UNITED STATES
NUCLEAR REGULATORY COMMISSION
WASHINGTON, D. C. 20555

SAFETY EVALUATION BY THE OFFICE OF NUCLEAR REACTOR REGULATION
RELATED TO AMENDMENT NO. 138 TO FACILITY OPERATING LICENSE NO. DRP-31
AND AMENDMENT NO. 139 TO FACILITY OPERATING LICENSE NO. DPR-41
FLORIDA POWER AND LIGHT COMPANY
TURKEY POINT UNIT NOS. 3 AND 4
DOCKET NOS. 50-250 AND 50-251

FIGURE 2-1
4160V ADDITIONS

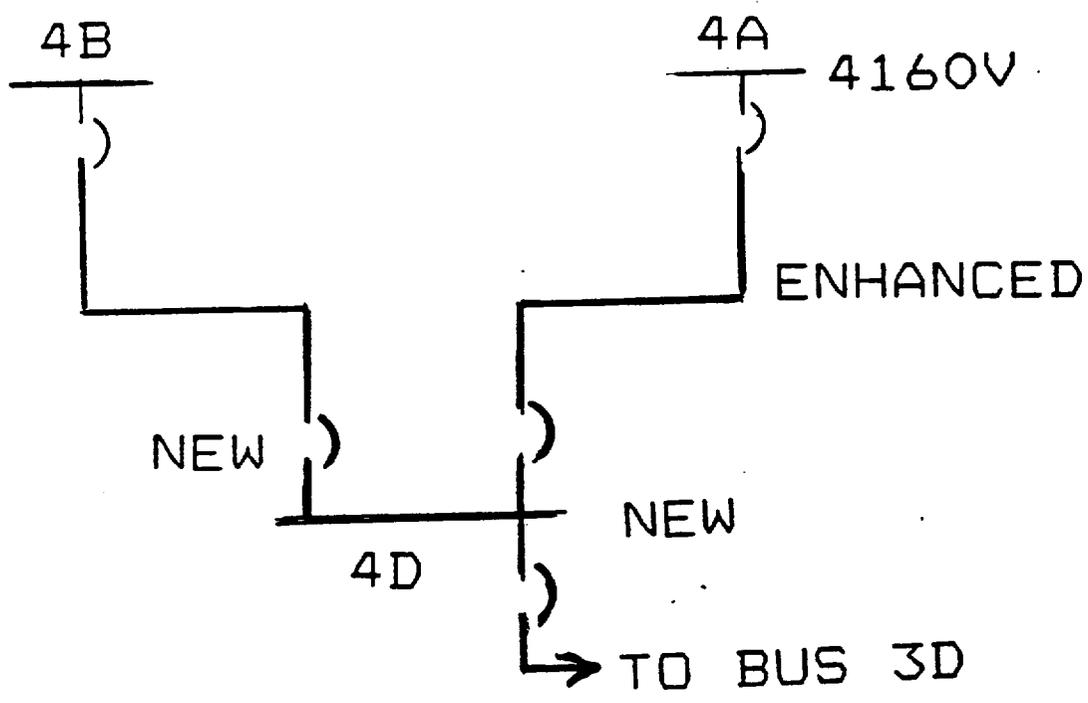
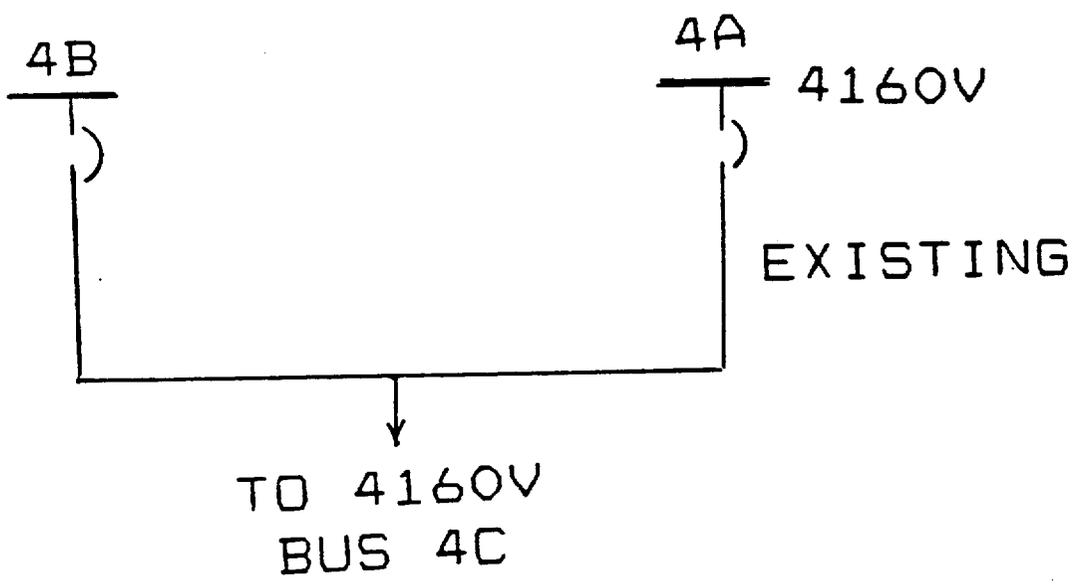
For unit 4, a new 4160V swing bus 4D will be connected to existing buses 4A and 4B. Similarly, a new 4160V swing bus 3D will be added to Unit 3 (see Figure 2-1). The swing buses power installed spare loads (i.e., component cooling water [CCW] or intake cooling water [ICW] pumps) when they are required to replace a non-operable Division A or B component cooling water pump or intake cooling water pump. The breaker cubicles in switchgear 3A/4A and 3B/4B previously supplying CCW 3C/4C and ICW 3C/4C pump motors will be reassigned as the power feeds to 4160V buses 3D/4D.

For a station blackout scenario, a new crosstie between buses 3D and 4D will be provided, including new tie breakers, one on bus 3D and one on bus 4D, to permit a manual crosstie between generating units 3 and 4. These tie breakers

will normally be open. The control circuitry includes permissives and interlocks to prevent inadvertent closure of the crosstie breakers. When the required permissives are satisfied, administratively controlled key-lock operated control switches (one for each unit) in the control room will permit closure of the tie breakers. Breaker indicating lights are provided in the control room.

RG 1.6 discourages the automatic transfer of safety loads from one power source to another. It is preferred that there is sufficient redundancy in the loads that an automatic transfer is not required. However, such redundancy does not always exist at older plants. As compared to the existing situation at Turkey Point, the addition of the 480V swing bus improves reliability by quickly re-energizing needed safety loads upon loss of power from the primary source. The automatic transfer should occur rarely and the interlock arrangement will prevent the inadvertent connection of two 480V trains. We therefore find the 480V swing bus addition to be acceptable.

FIGURE 2-2
480V ADDITIONS

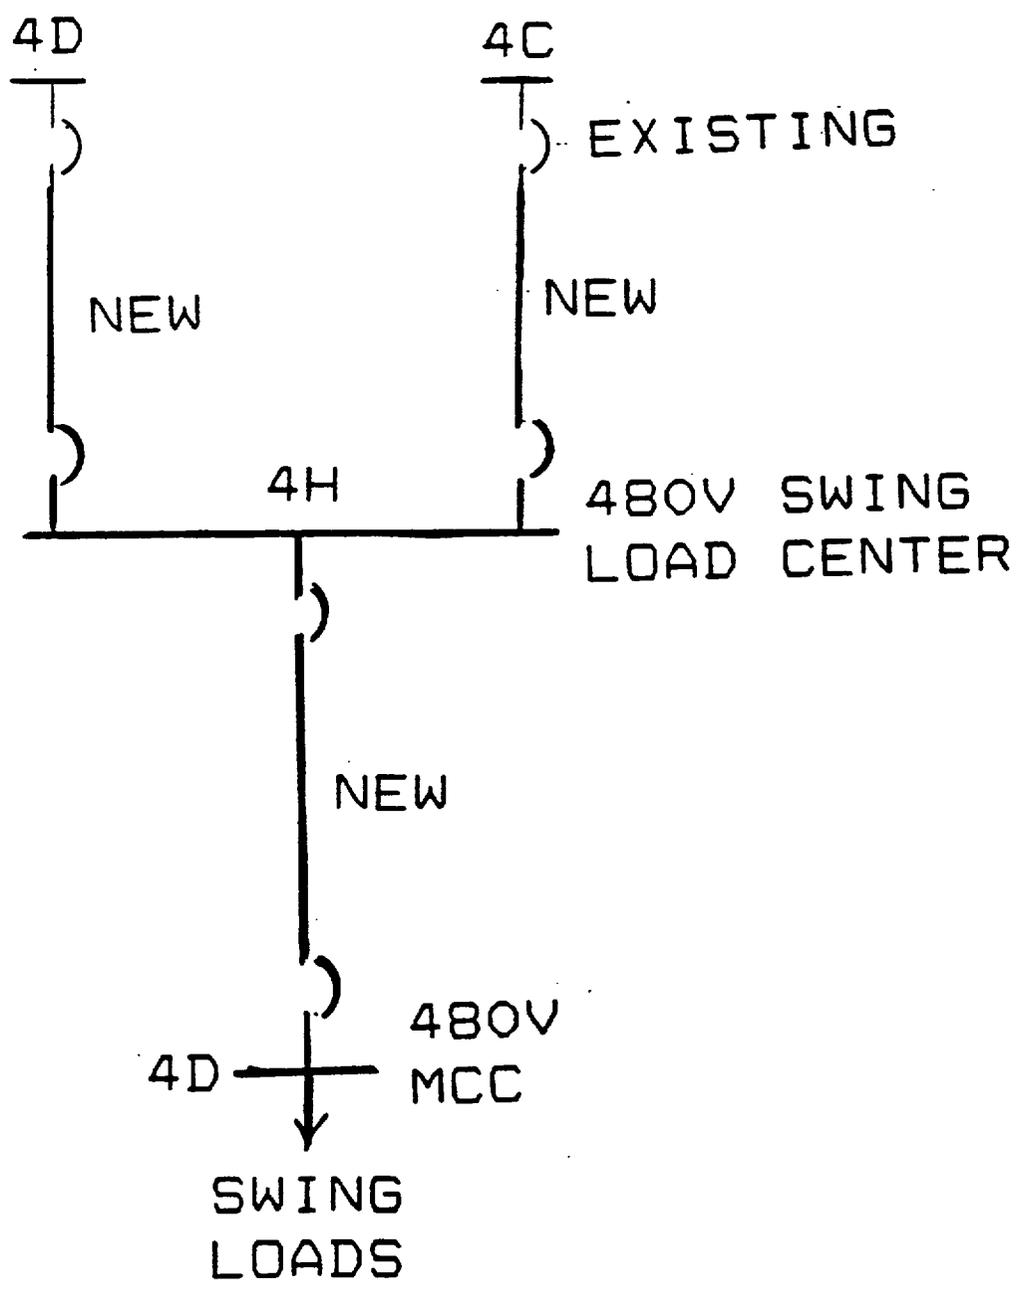
For unit 4, a new 480V load center swing Bus 4H powered by existing 480V load centers 4C or 4D is being added. Similarly for Unit 3, a new 480V load center swing Bus 3H powered by existing 480V load centers 3C or 3D is being added. Each of the two tie lines to the 480V swing buses have two breakers (See Figure 2-2). The breakers will have position indication in the main control room. Each swing load center can be aligned to either Train A or Train B of its associated unit. For each 480V load center, if the bus to which it is connected loses power, automatic circuit breaker operation connects the bus to the other power source if power is available there. The breakers have interlock logic to prevent simultaneous connection of the swing bus to Divisions A and B.

For unit 4, three new 480V MCCs 4D, 4J and 4K will be powered respectively by a new 480V load center swing bus 4H and by existing 480V load center Buses 4A and 4D. For unit 3, a new 480V MCC 3K will be powered from existing load center 3D. Existing MCC D will be relabeled 3D and powered by a new 480V load center swing Bus 3H. New MCC 4J will power the new EDG 4A fans and auxiliaries, 4K the new EDG 4B fans and auxiliaries, and 4D the existing unit 4 swing loads (See Figure 2-2). New MCC 3K will power the EDG 3B auxiliaries which are presently powered by MCC 4B. Existing MCC 3A will continue to power the EDG 3A auxiliaries. The existing shared MCC 4D will be relabeled 3D, connected to the new swing load center 3H, and used to power existing unit 3 swing loads.

FIGURE 2-3
125 DC BUSES

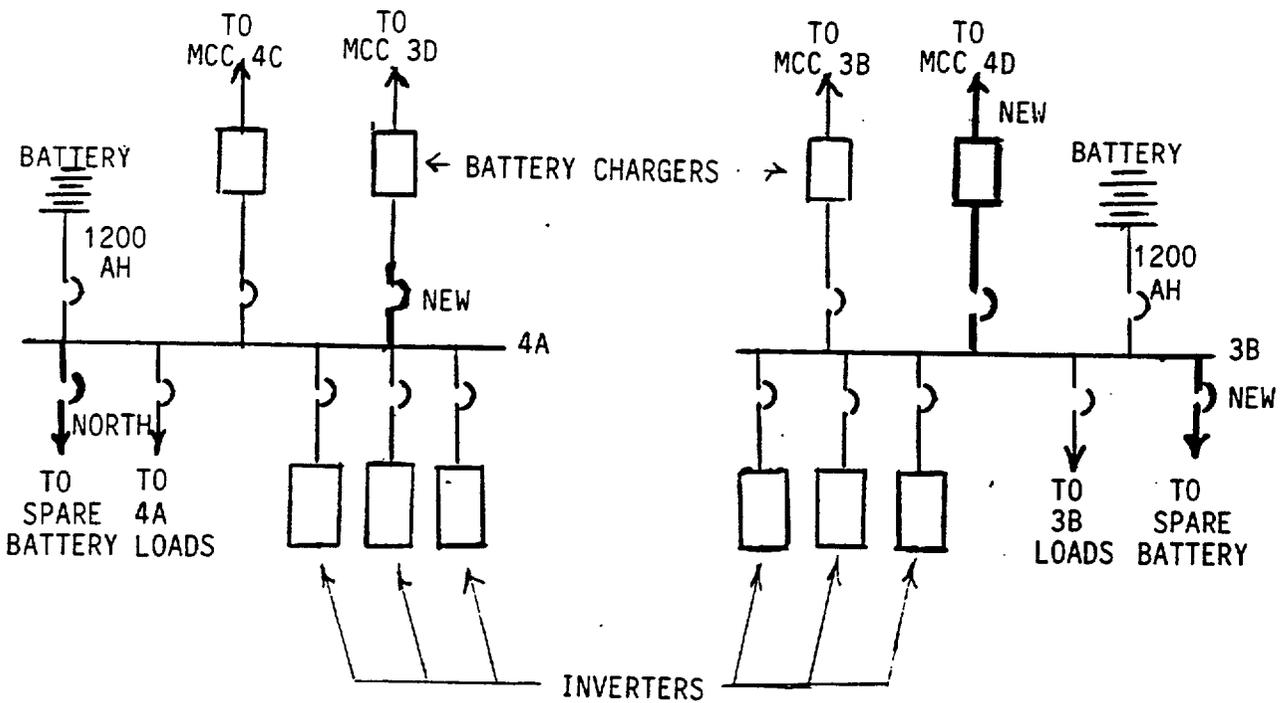
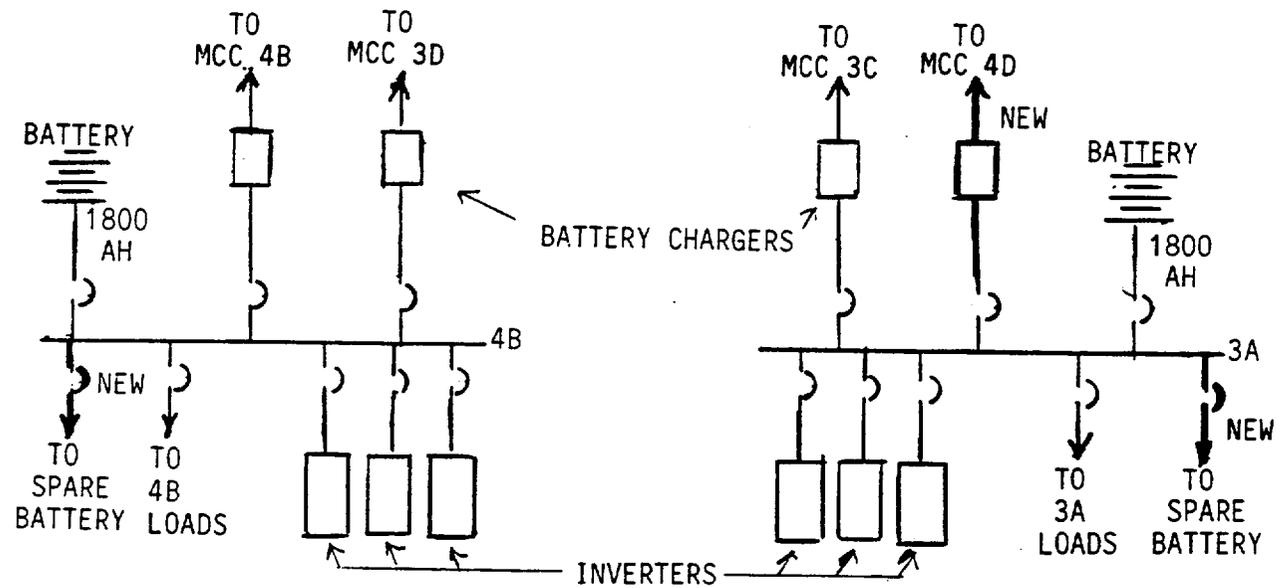
The existing six battery chargers are being replaced and two new battery chargers are being added such that each dc bus will have two full capacity chargers. One of the chargers on each dc bus will be powered from a motor control center from the same unit and division (i.e., the battery charger to dc bus 3A will be powered from a unit 3, Division A MCC, etc.). The second battery charger on each dc bus will be powered from the swing MCC from the other unit (i.e., the second battery charger to dc bus 3A will be powered from MCC 4D, etc.) After the system changes, each 125V dc bus will have two battery chargers; one supplied from each unit (See Figure 2-3).

FIGURE 2-4

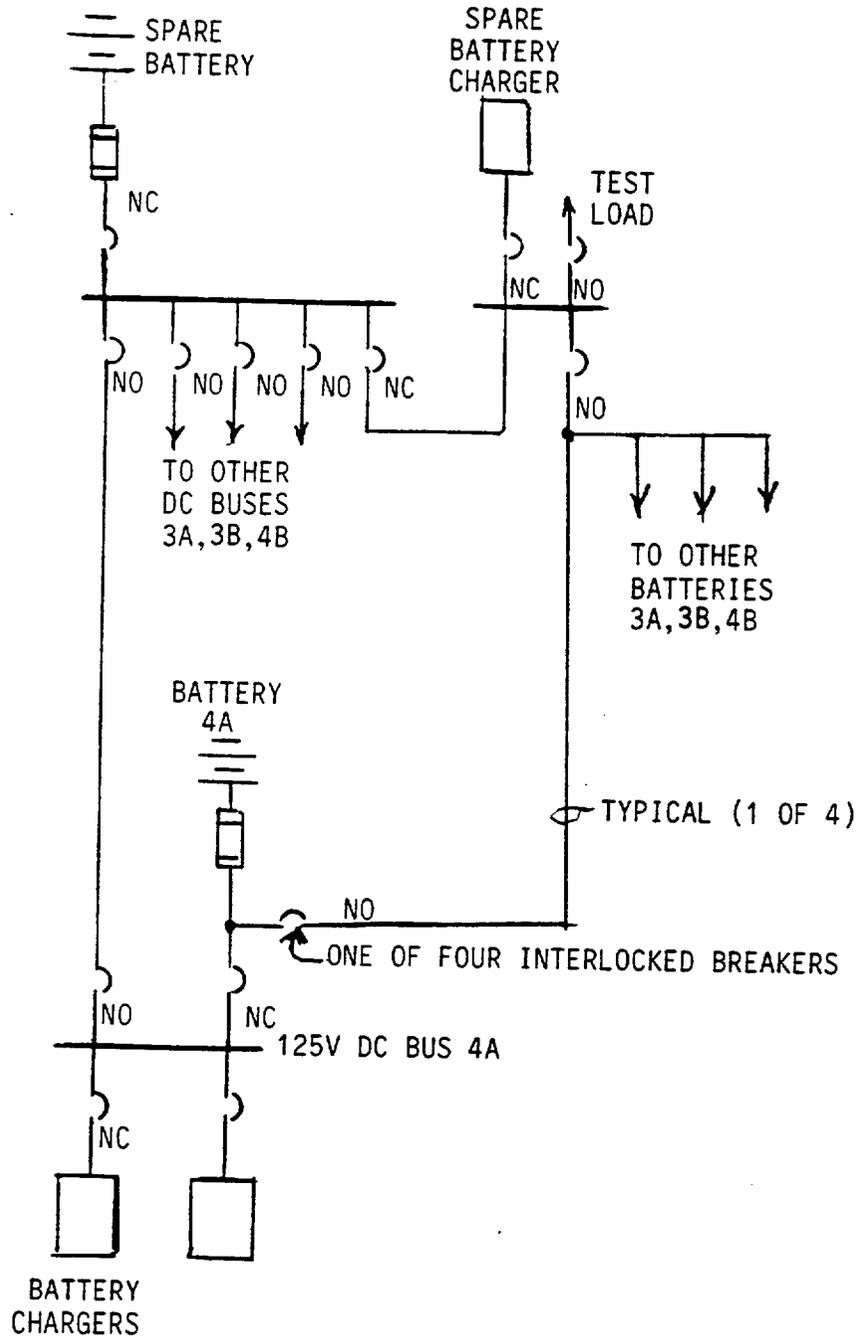
Presently, 125V dc buses 3A and 4B have a normally open tie between them which may be temporarily closed when testing either battery. A new Class 1E spare battery will be added with provisions for connecting to each 125V dc bus. Non-automatic circuit breakers with kirk key locks will prevent the spare battery from being connected to more than one 125V dc bus at a time (see Figure 2-4). The spare battery will be used to power a 125V dc bus while the normal dedicated battery is being tested and recharged (e.g., for the performance discharge or battery capacity tests). The spare battery will first be paralleled with the normal battery using the key-locked breaker. Then, the normal battery will be disconnected from the 125V Class 1E bus and connected to the test load (see Figure 2-4).

*However, current practice is to connect 125V dc Bus 3A or Bus 4B to the existing C-bus batteries, and not to each other, whenever battery testing is required.
